London Borough of Havering **Highways**

Date: 26th October 2020

Please find below our response to the Regulation 28 (Preventing Future Deaths) report sent to us on 4th September 2020, reference

Unobstructed lamp column at the controlled crossing point.

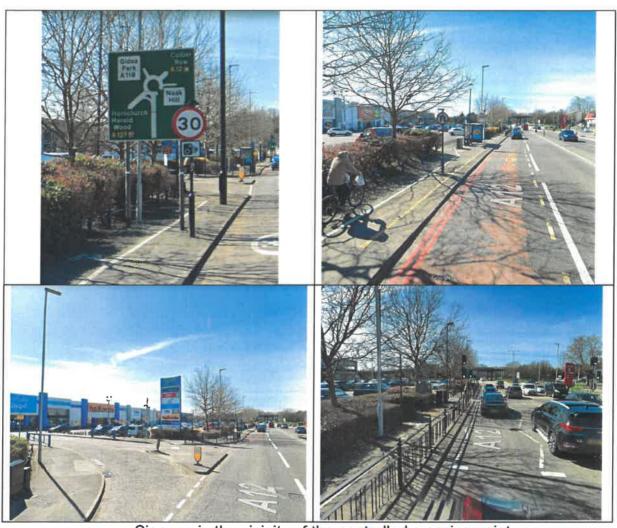
POINT 1. The Inquest heard that there are a number of items of street furniture that obstruct the view that drivers should have of pedestrians waiting at the Pelican crossing (signage, bus stand, safety camera and overhanging foliage/tree branches). While the report does not state which side of the crossing point the incident occurred, the bus stand and safety camera are on the south east footway so it is this location that has been investigated.

Upon insection on the 17th September 2020 all the trees that are contained within the grounds of the Gallows Corner Retail Park were found to be well cut back, with no branches lower than six foot overhanging the footway. There were no braches overhanging the carriageway at all. At the crossing point itself there is a street light that illuminates the crossing point at night, and this area was found to be completely clear of any over hanging branches so there would be no shadows over pedestrians waiting to cross at this point on the footway.
